Texas A&M University - Corpus Christi Chaparral Building Renovations

TAMU-CC Project #157191FY21 TAMU-CC Proposal #CSP3-003

Issue Date: 09/07/2023

MAKE THE FOLLOWING ADDITIONS, MODIFICATIONS OR DELETIONS TO THE DRAWINGS AND SPECIFICATIONS

S2

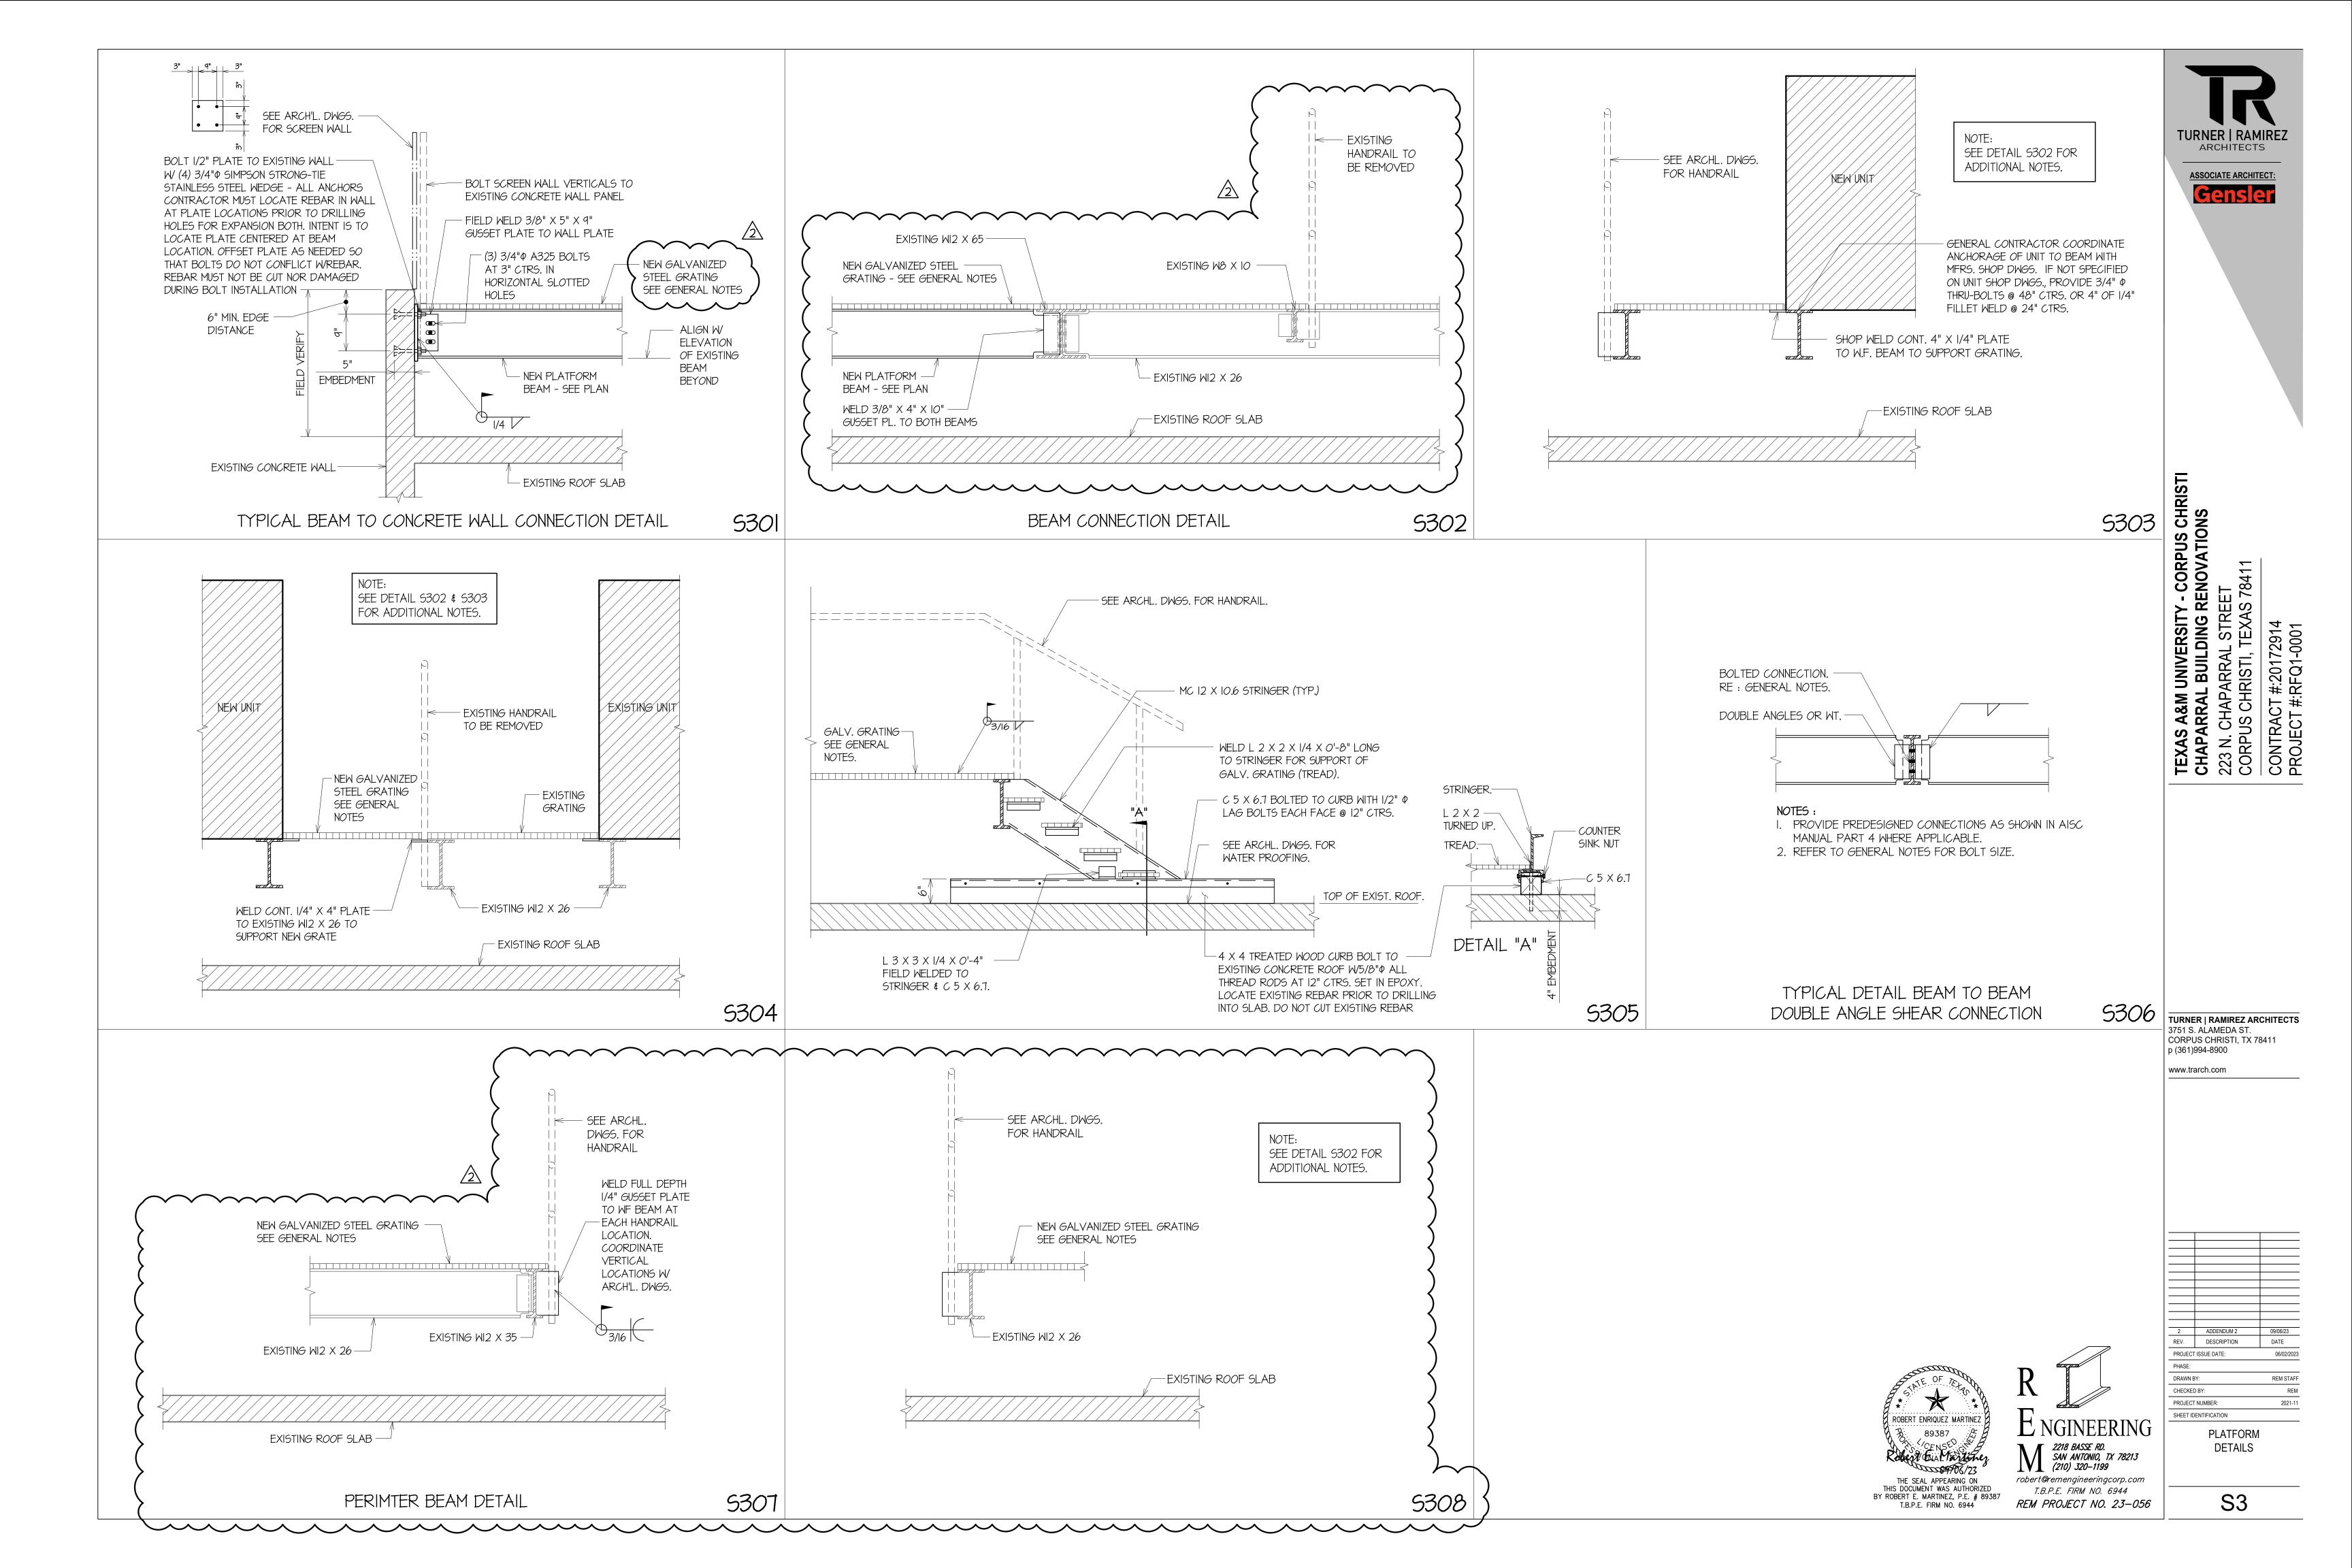
- ITEM No.03 REPLACE Sheet S2 GENERAL NOTES [Dated 06/02/2023] with revised & attached Sheet S2 GENERAL NOTES [Dated 09/06/23].
- ITEM No.04 REPLACE Sheet S3 PLATFORM DETAILS [Dated 06/02/2023] with revised & attached Sheet S3 PLATFORM DETAILS [Dated 09/06/23].
- ITEM No.05 ADD Sheet S4 PLATFORM FRAMING PLAN attached.

E1.100

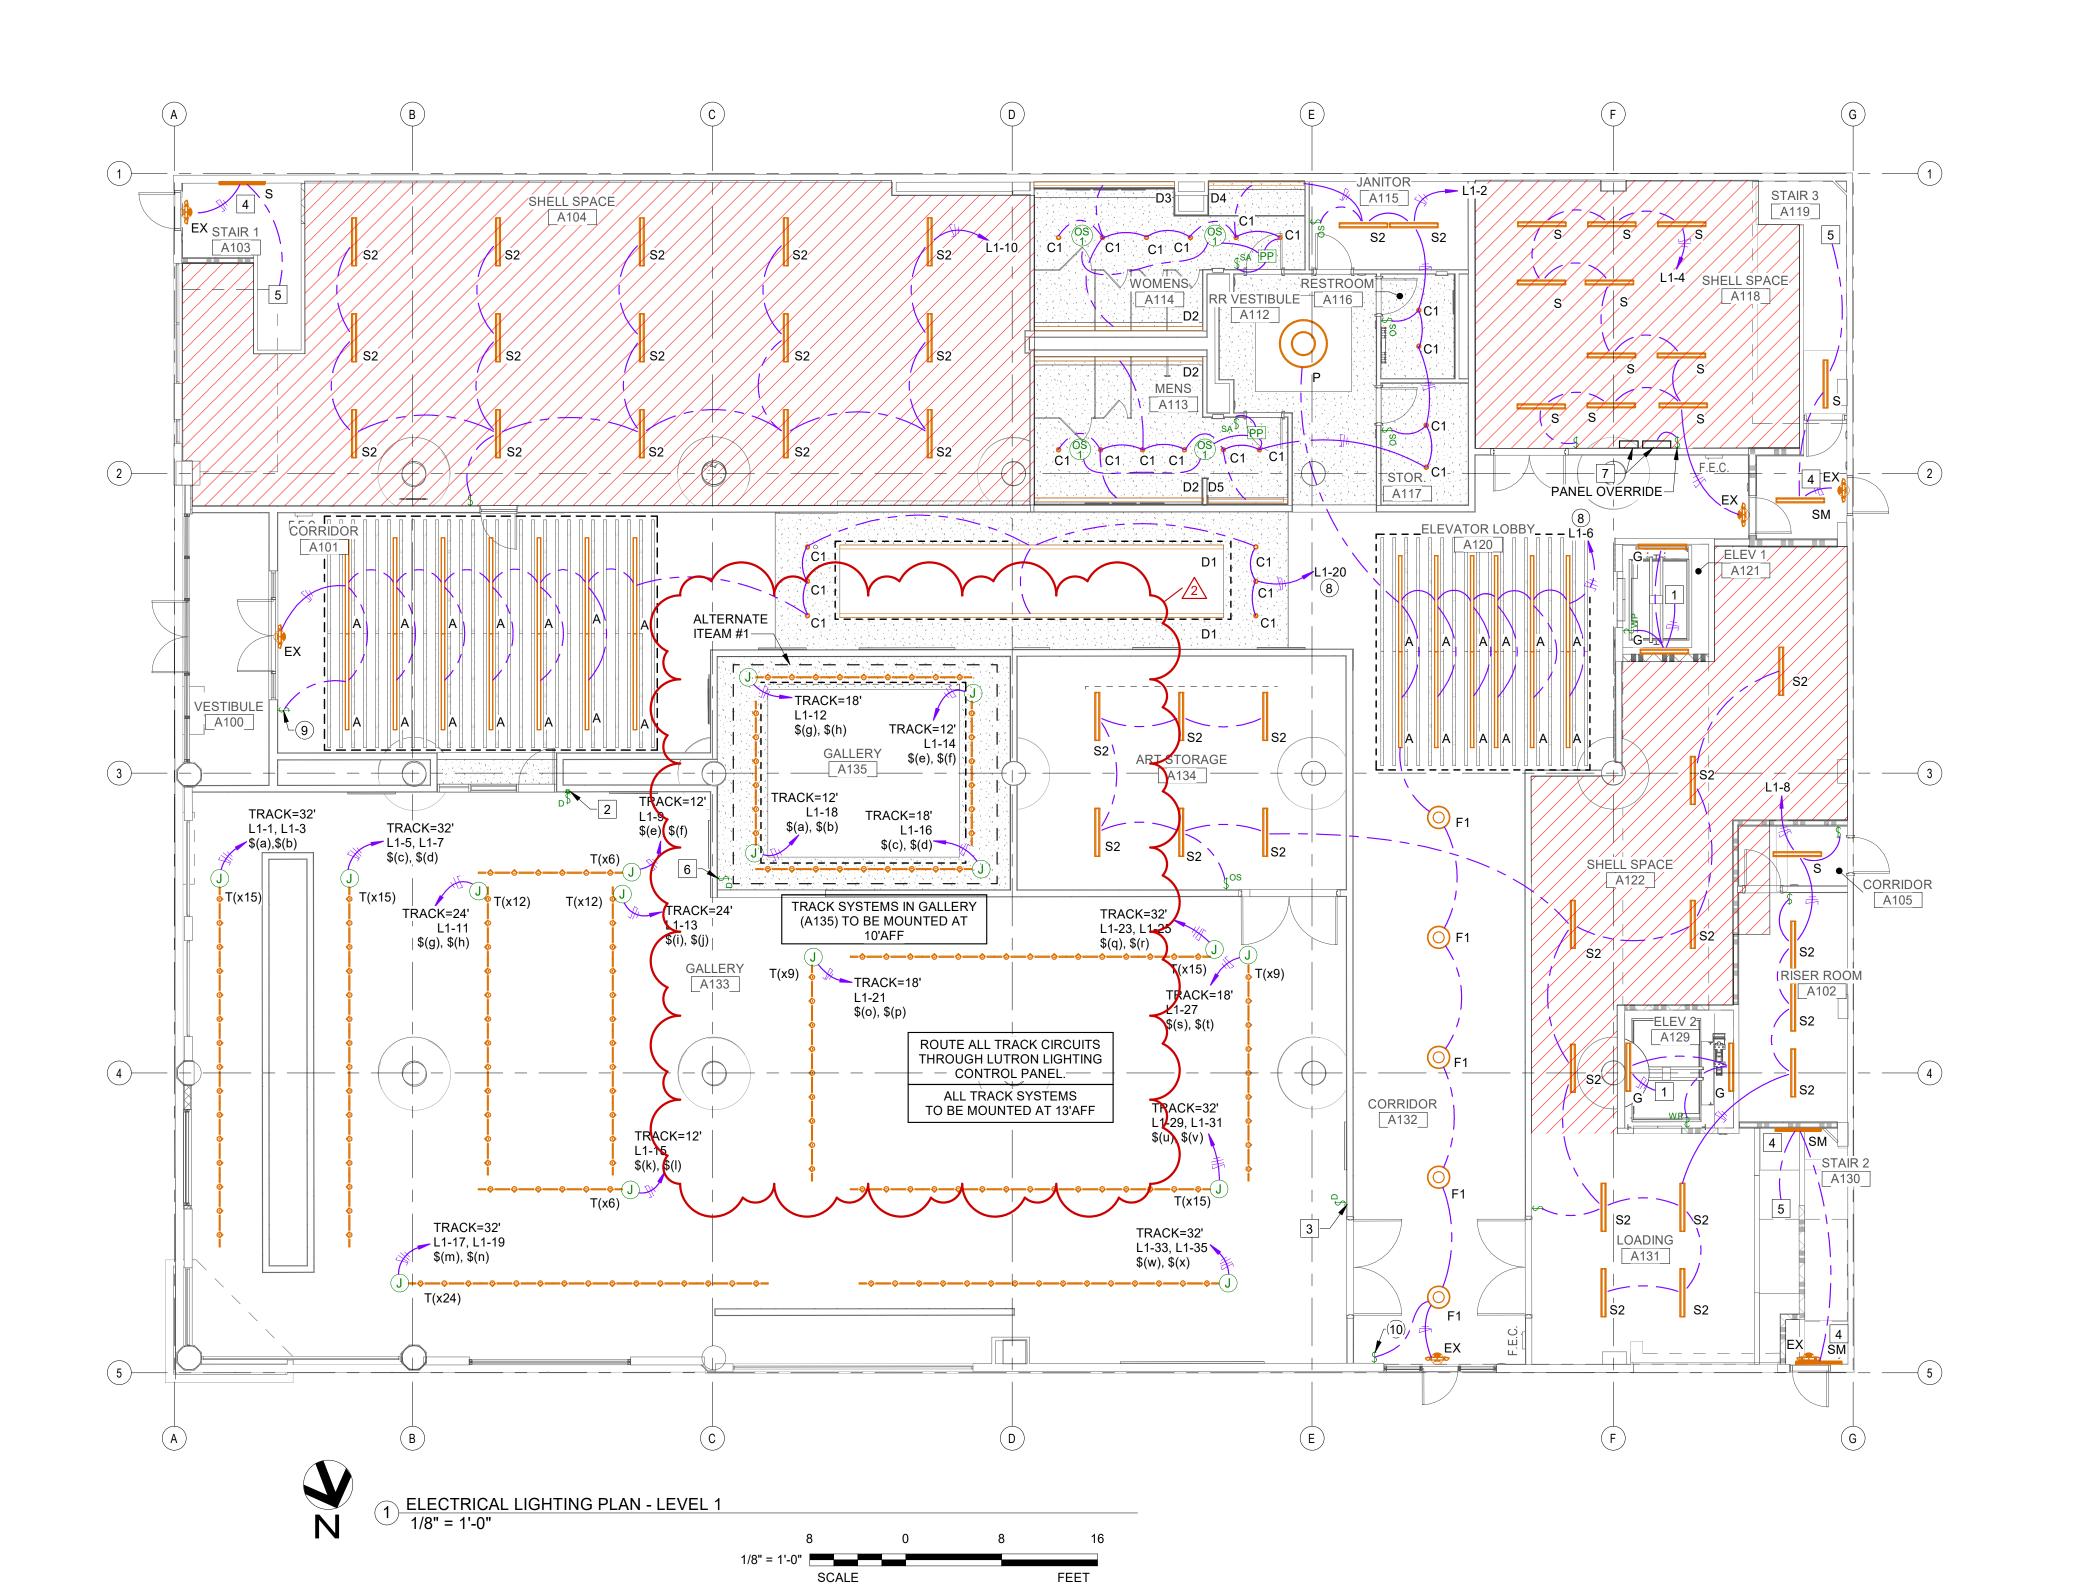
- ITEM No.01 REPLACE Sheet E1.100 ELECTRICAL LIGHTING PLAN LEVEL 1 [Dated 08/04/2023] with revised & attached Sheet E1.100 ELECTRICAL LIGHTING PLAN- LEVEL 1 [Dated 09-07-23].
